WSU BANKSTOWN CITY CAMPUS | SSD_9831

CONSOLIDATED RESPONSE TO DPIE RFI DATED 4 NOVEMBER 2020 AND ADDITIONAL INFORMATION REQUESTED DATED 11 DECEMBER 2020.

TABLE 1 - Response to DPIE Additional Information Request dated 11 December 2020

Table 1: A comparison of waste and recycling volumes

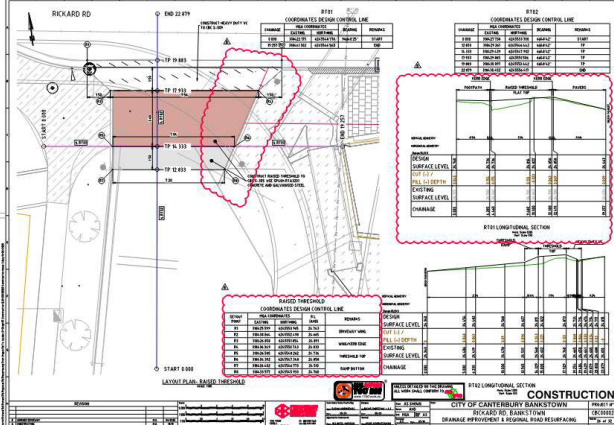
Tree removals are now complete, and Trees 22 and 23 protected as approved/required by DA 697/2019.
9.0	Waste	
9.1	The Department requested that the application amend or clarify waste generation rates. This has not been addressed.	<p><u>Elephants Foot Response:</u></p> <p>A combination of rates has been used to estimate the volumes of waste and recycling in the future building as it is Elephants Foot Recycling Solutions' view that the rate for Tertiary Education currently detailed in the NSW EPA's <i>Better Practice Guide for Resource Recovery In Residential Developments 2019</i> significantly overestimates the actual volumes of waste and recycling generated by university buildings.</p> <p>Accordingly, Western Sydney University (WSU) has provided operational waste management data from an existing building within their campus that has a comparable population and operations to the proposed Bankstown campus. It is understood that the operational data has been attained from a university building with a population of 2998.</p> <p>Please see below a summary of the operational data from the existing WSU building:</p> <ul style="list-style-type: none"> 5x 660L general waste bins collected daily 3x 660L paper/cardboard recycling bins collected daily 2x 660L co-mingled recycling bins collected daily 2x 240L food/organic bins collected daily <p>Table 1 below details a comparison between the operational data from the existing WSU building, the volume estimated from the Operational Waste Management Plan (OWMP) Revision H August 2020 and the volumes estimated using the tertiary education rate from the <i>Better Practice Guide for Resource Recovery In Residential Developments 2019</i>. To ensure consistency between figures, the calculations assume the proposed building will have a population of 2000 students and 250 staff at any one time and a 5-day operating week</p>

For the purposes of waste room design in the proposed building, it is recommended that the rates in the OWMP Rev H Aug2020 are maintained. As shown in the table above, the volume estimates per day in the OWMP are around 170% higher for waste and 168% higher for the recycling than the total volumes of waste and recycling from operational data. Therefore, the estimates in the OWMP Rev H are likely to result in waste rooms that are an appropriate size, while still considering a possible "worst case scenario".

In addition, it is our belief that current waste and recycling generation rate for Tertiary Education within the NSW EPA *Better Practice Guide for Resource Recovery in New Developments 2019* can be easily corrected. If the rate were to be applied per student per week, rather than per student per day then the estimated volumes would be very similar to the operational data in the table above. Hence, our view that this is simply a typographic error in the document.
